June 28, 2014

License Amendment Request – Re-drying Honeymoon Dried Yellowcake – RAI Response Package
Uranium One USA, Inc.
Materials License No. SUA-1341
Docket No. 40-8502 – TAC No. J00721

RAI-1

Figure 4.1
Irigaray Process Unit
Drying/Packaging Unit Schematic

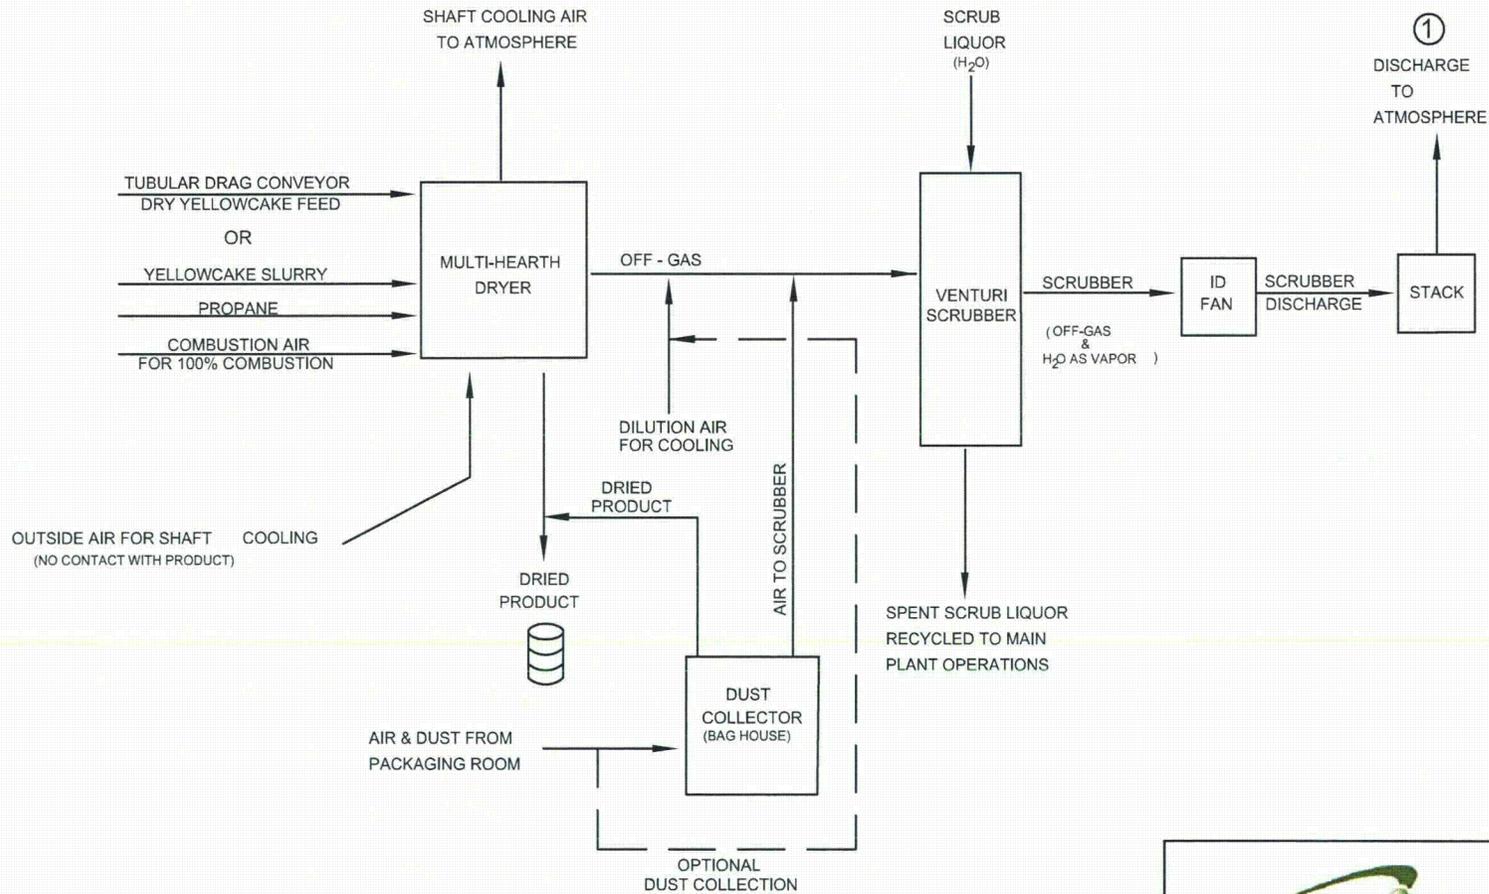
The proposed changes to the NRC-approved process flow path have not been incorporated in a second related drawing. In particular, NRC staff has determined that License Renewal Application, Figure 4.1, Irigaray Process Unit Drying/Packaging Unit Schematic, should also be updated similar to Figure 3.11.

The licensee shall provide an updated License Renewal Application, Figure 4.1, as part of the application process, or commit to updating Figure 4.1 through the performance-based license condition (License Condition 9.4).

Figure 4.1 (attached) of the License Renewal Application has been revised to reflect the re-drying of the Honeymoon yellowcake at the Irigaray facility.

Figure 3.10a

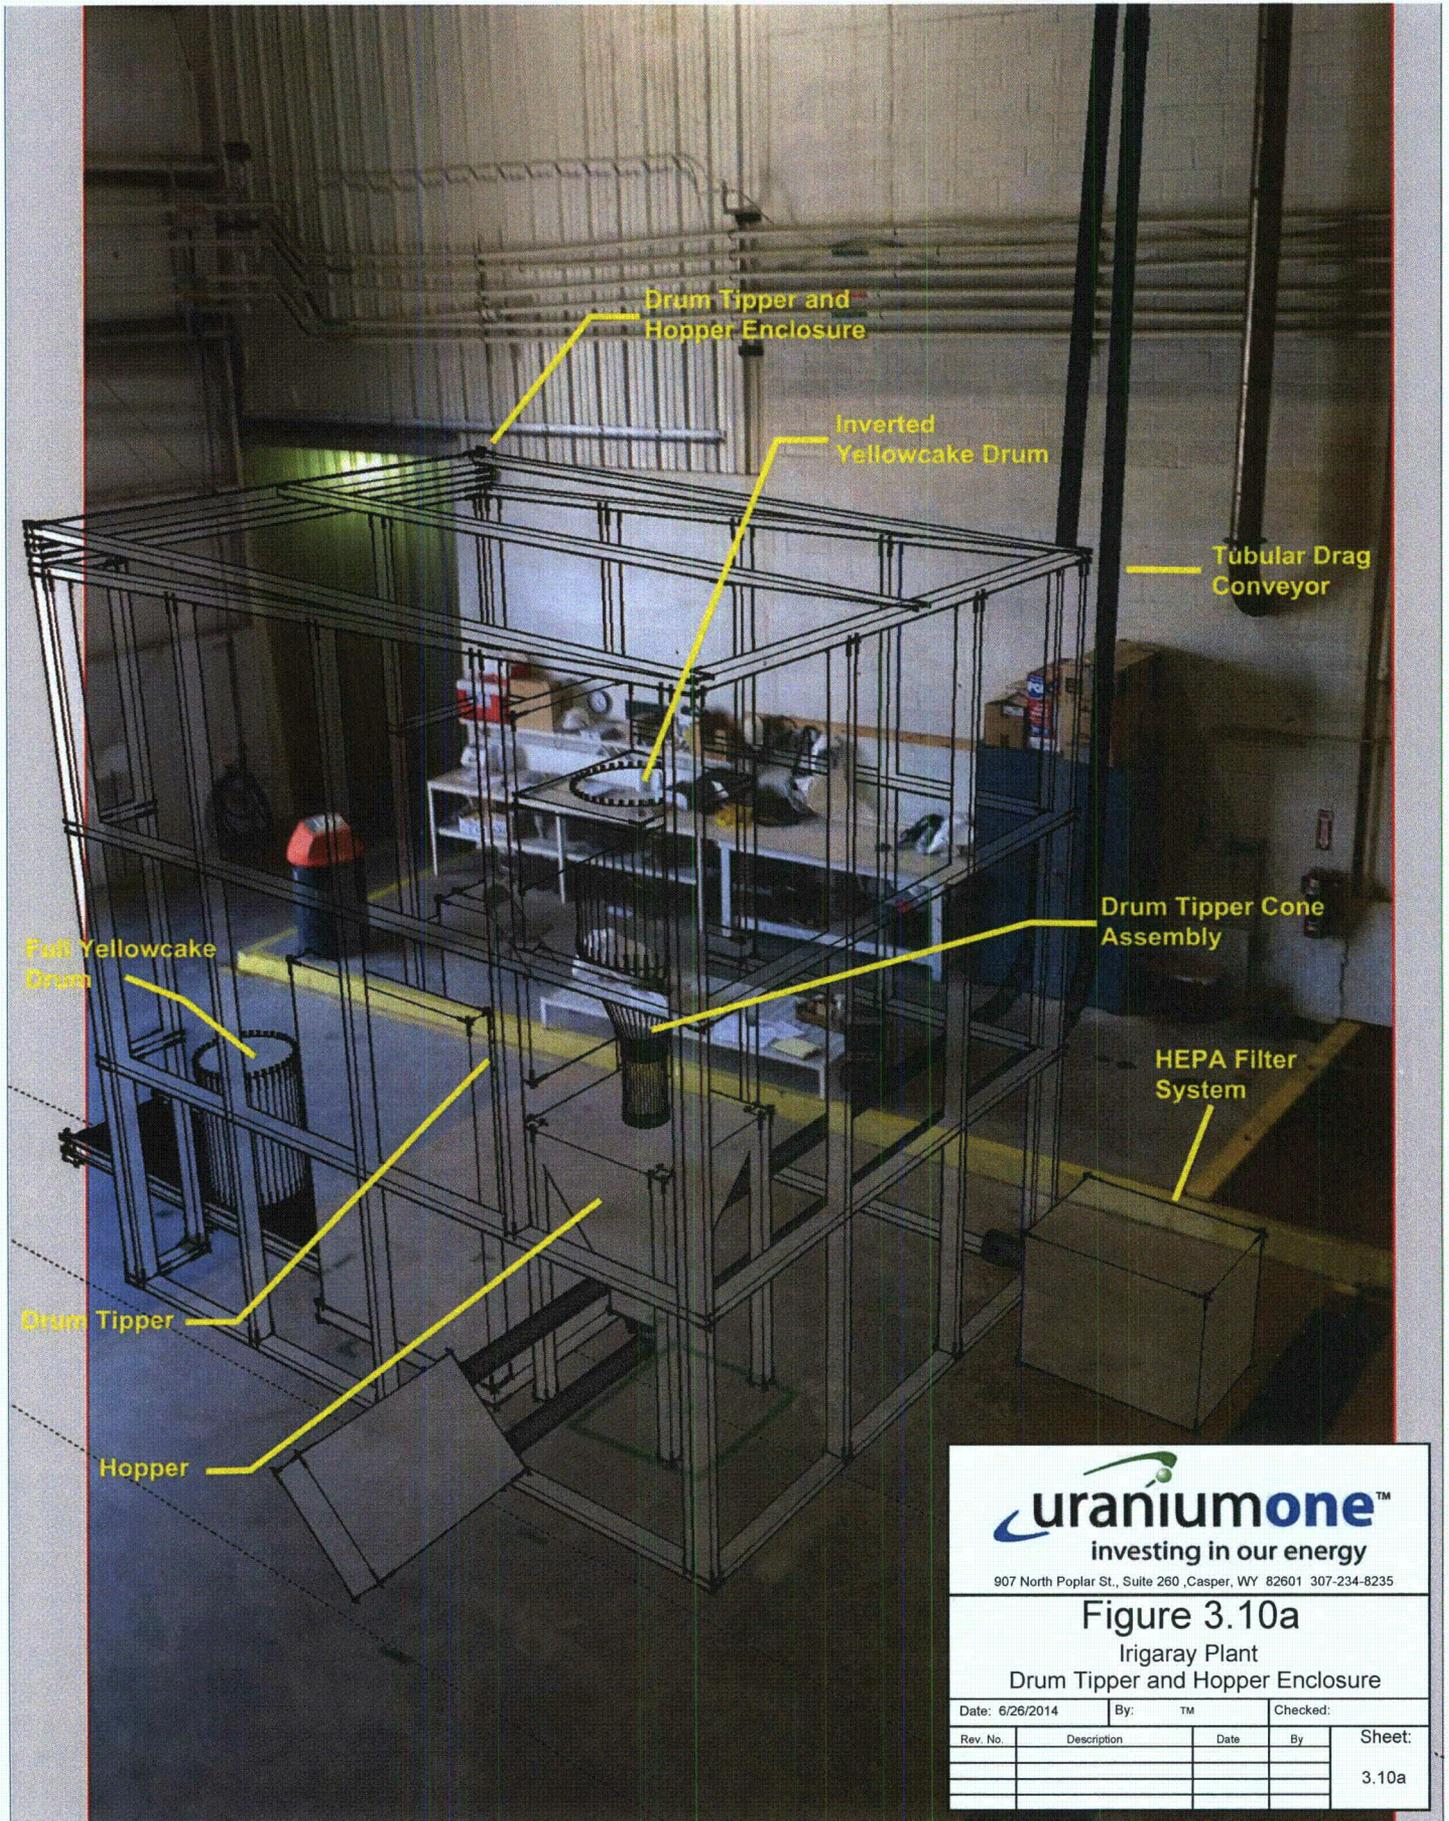
The licensee shall demonstrate that the drum tipping station and interconnected conveyance system are isolated from other accessible facility areas, or provide adequate (portable) containment and ventilation (with filtration) to prevent potential dispersion of yellowcake to other accessible facility areas. That is, the licensee shall describe its proposed radiological controls for any location or operational situation where the Honeymoon yellowcake is not fully contained within an enclosed space.

In an effort to further minimize potential employee exposures Uranium One will isolate the drum tipping system from the general plant with a temporary enclosure and separate HEPA ventilation system as shown in Figure 3.10a. The proposed HEPA ventilation system will maintain a negative pressure on the enclosure and provide an air exchange approximately every 5 minutes for the enclosure. Uranium One will have standard operating procedures ("SOP's") developed prior to start-up of the Honeymoon re-drying program that will address industrial safety, radiological and maintenance/contingency protocols to be followed.
